CANDLEWOOD SUITE HOTEL | CHERRY HILL SWEDISH CAMPUS

PLAN CHANGES FROM 09-11-2019 SAC MEETING - HOTEL PROPOSAL

505 16TH AVE, SEATTLE

L1 FLOOR PLAN - PROPOSED

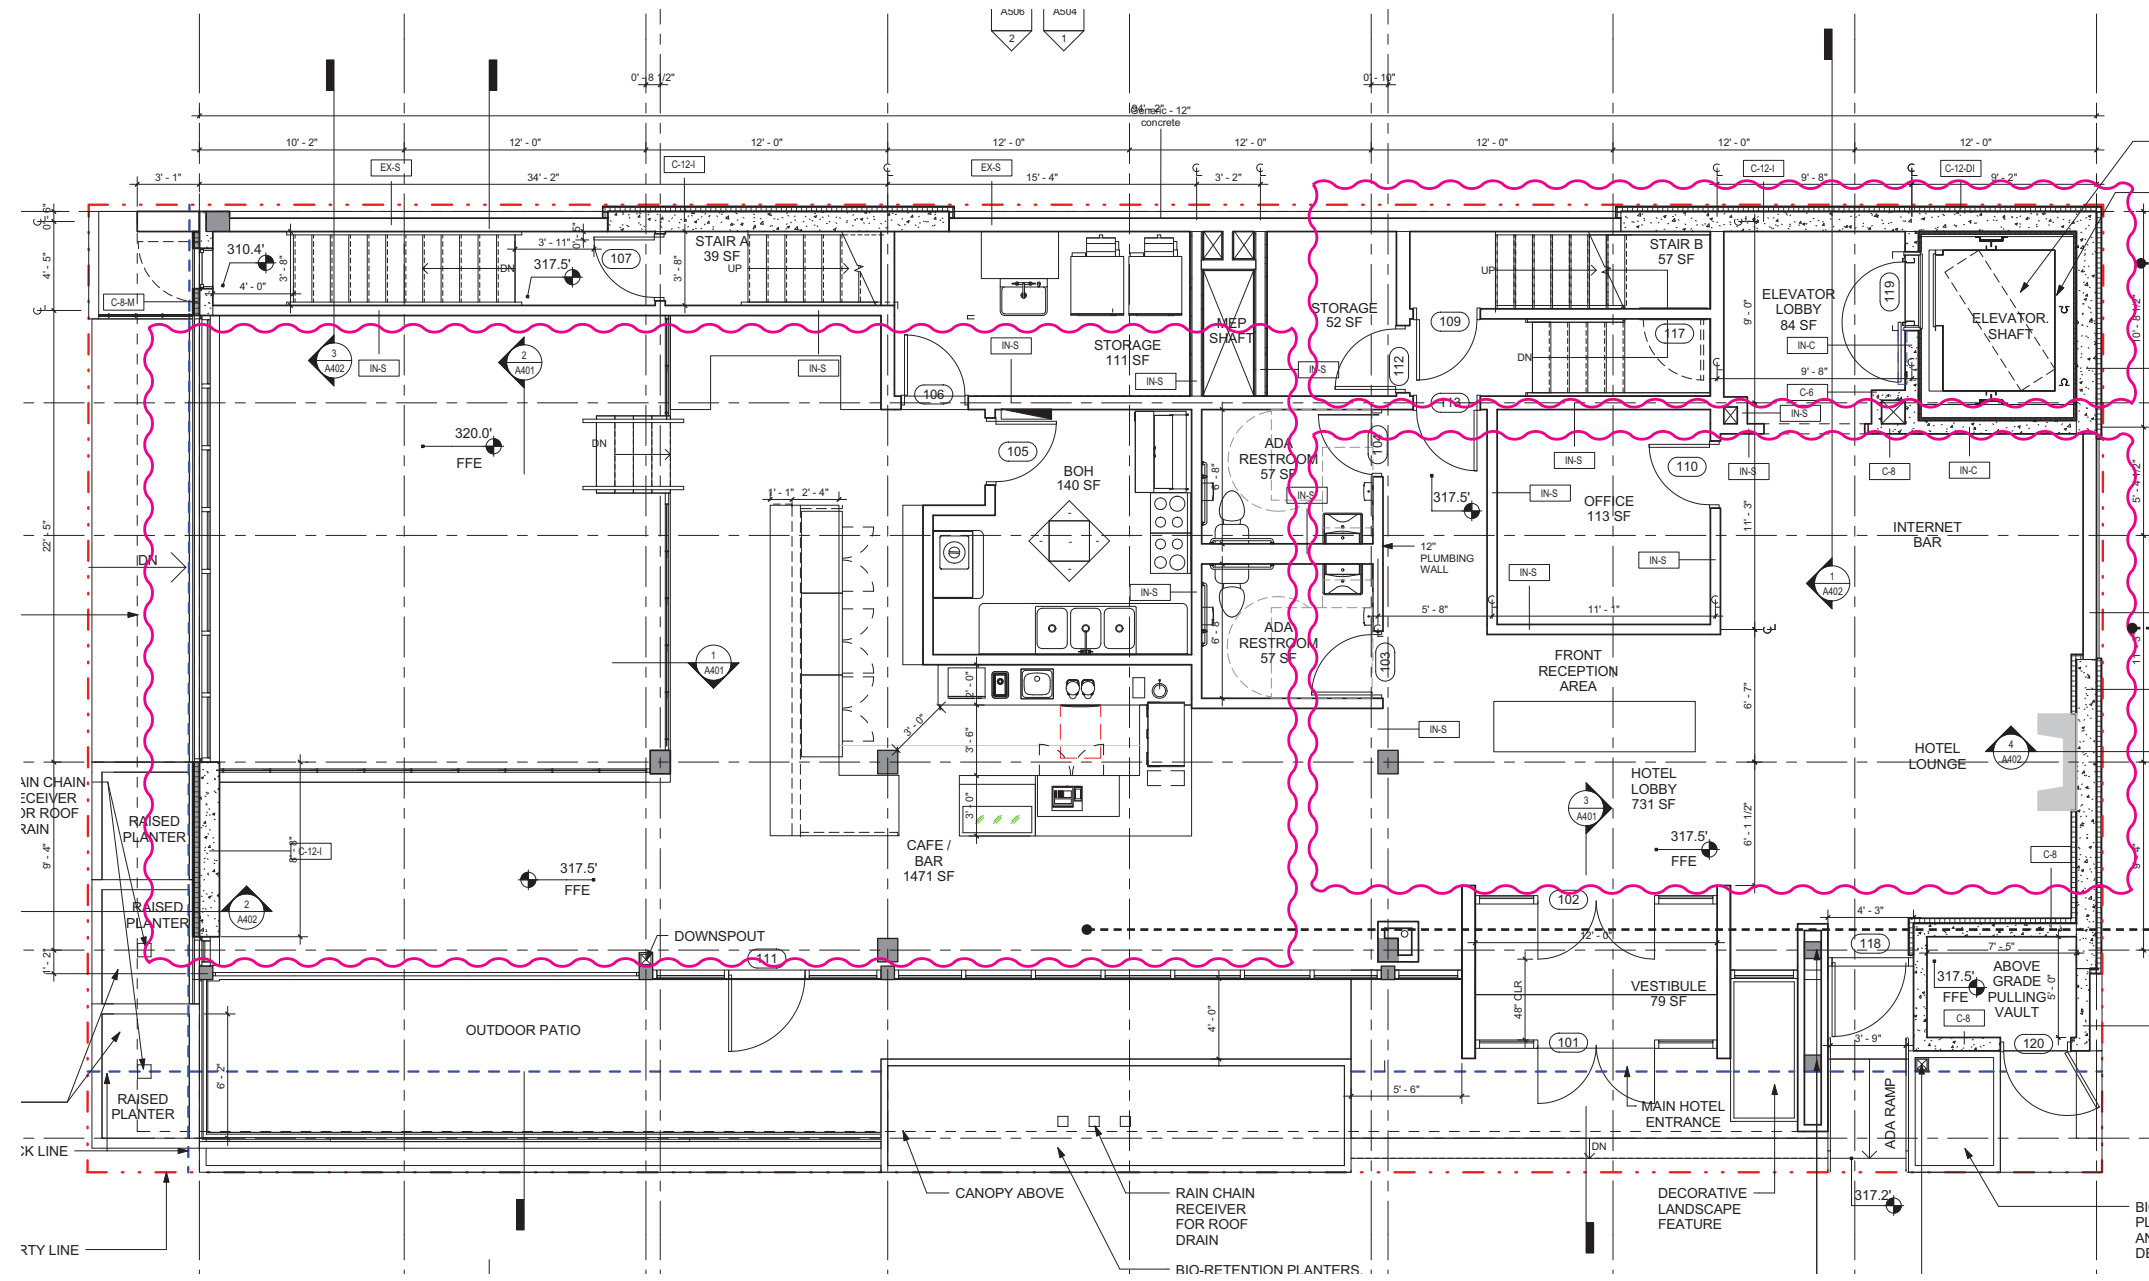
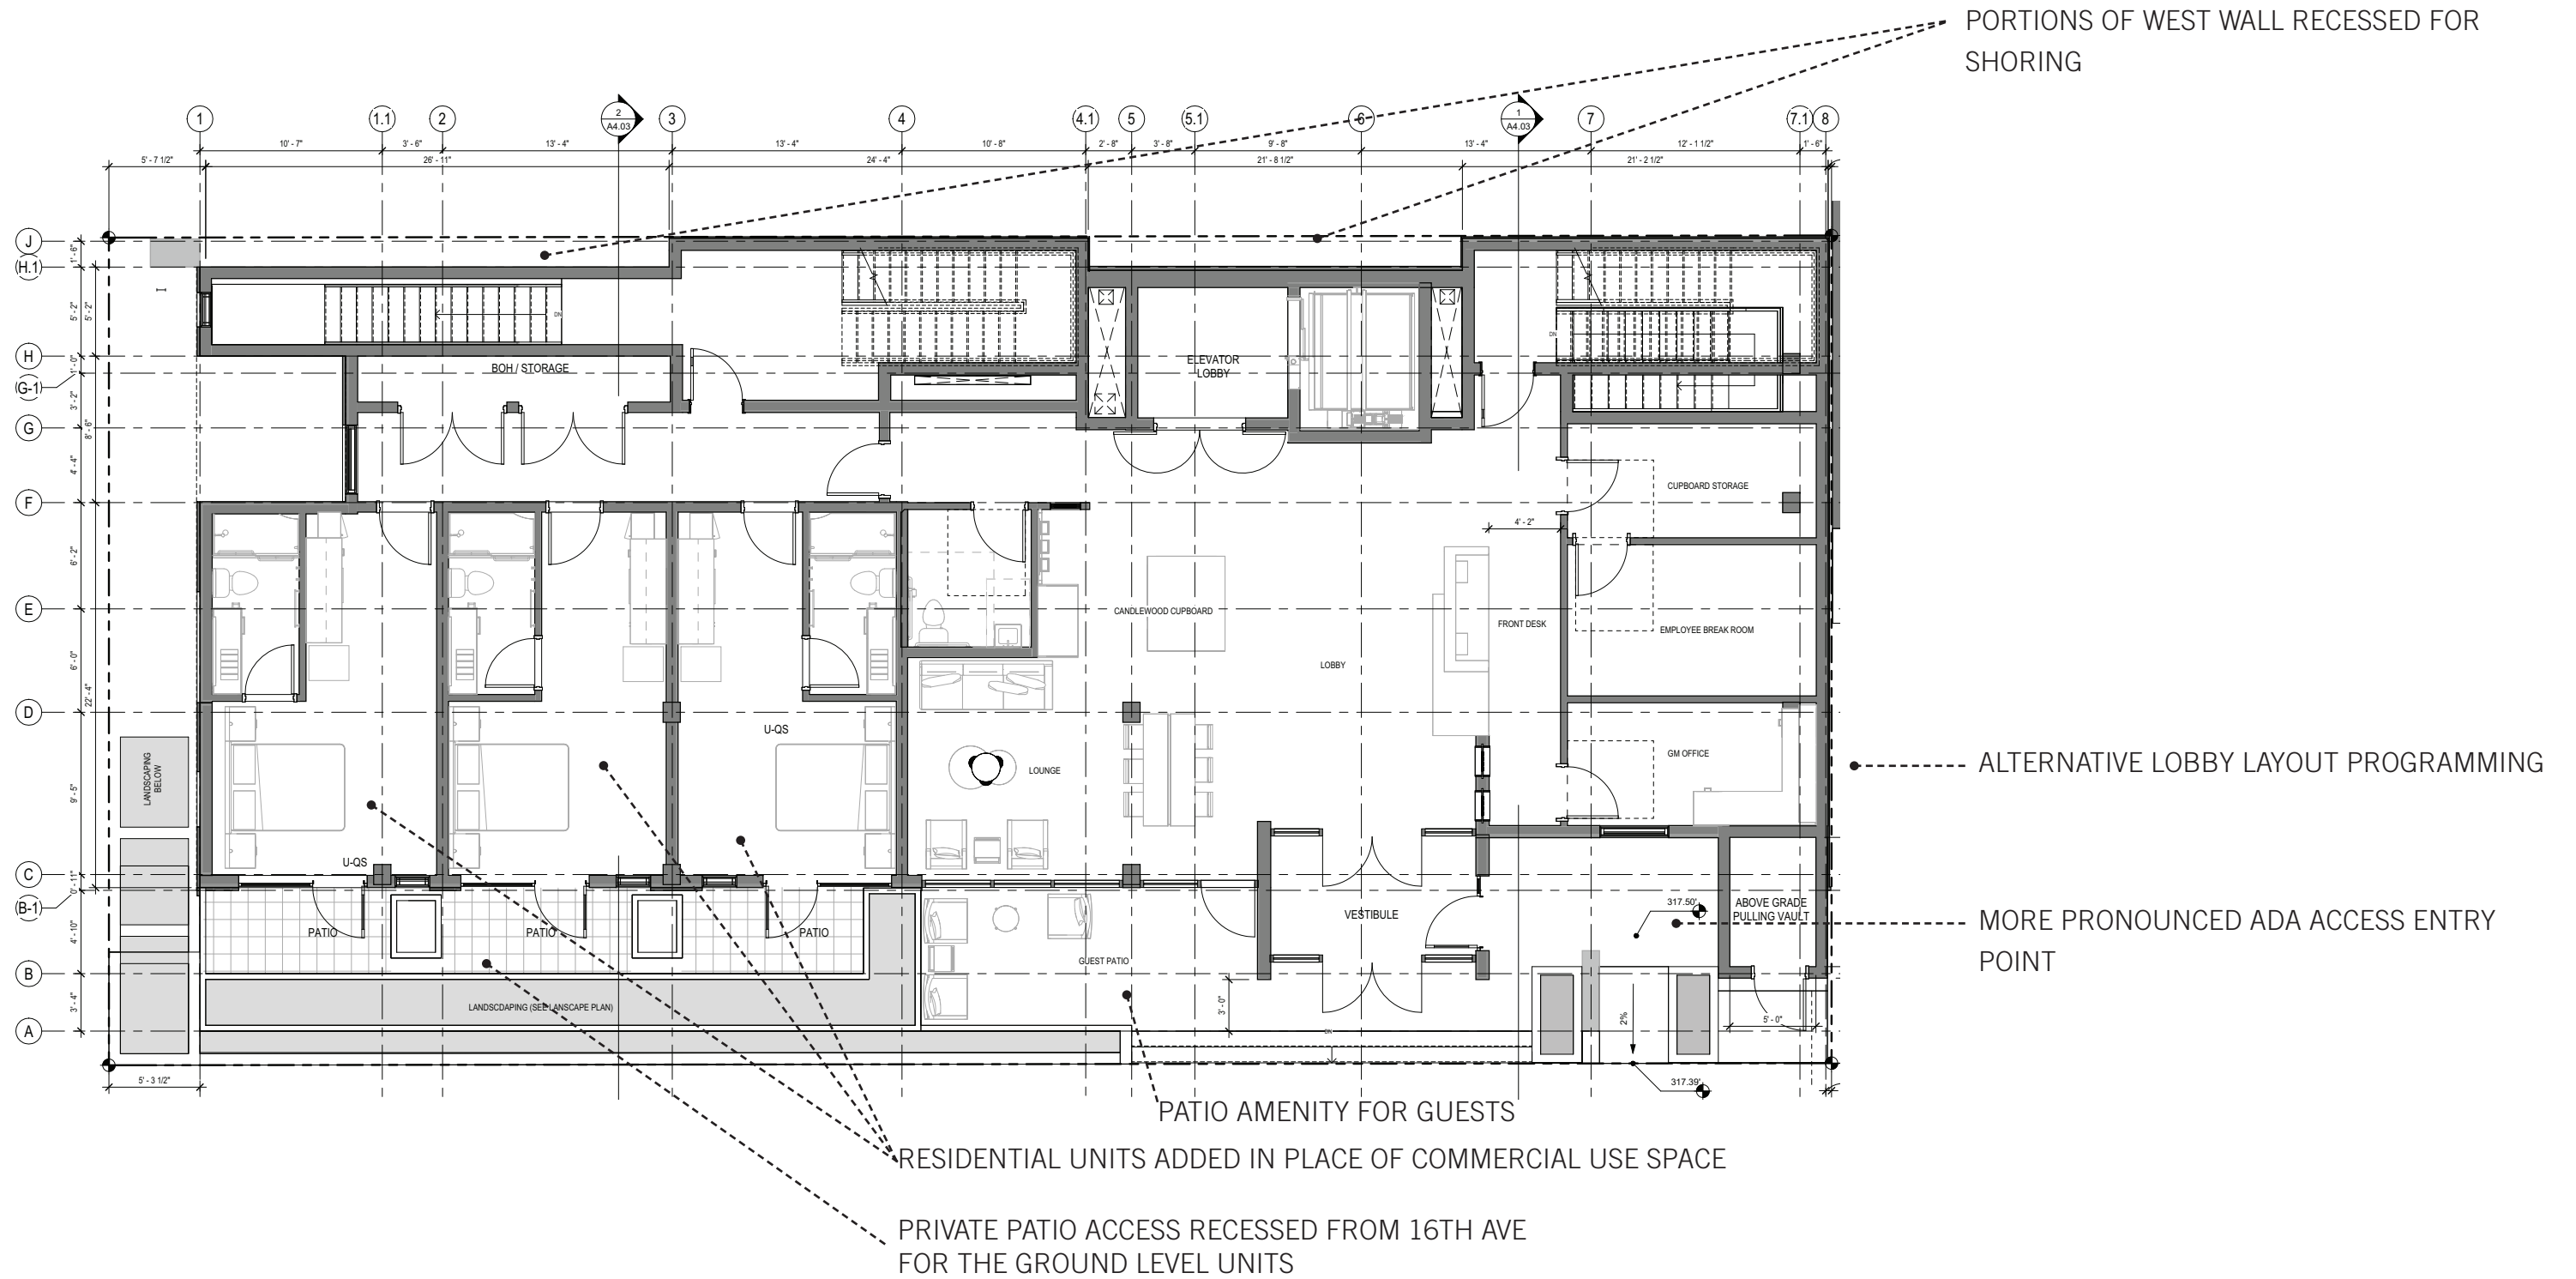
STAIR AND ELEVATOR LOCATIONS ARE REVERSED

LOBBY PROGRAMMING CHANGED

CAFE/RESTAURANT IS ELIMINATED AS CANNOT BE SUPPORTED BY CURRENT OPERATOR (CANDLEWOOD SUITES)

OUTDOOR PUBLIC PATIO
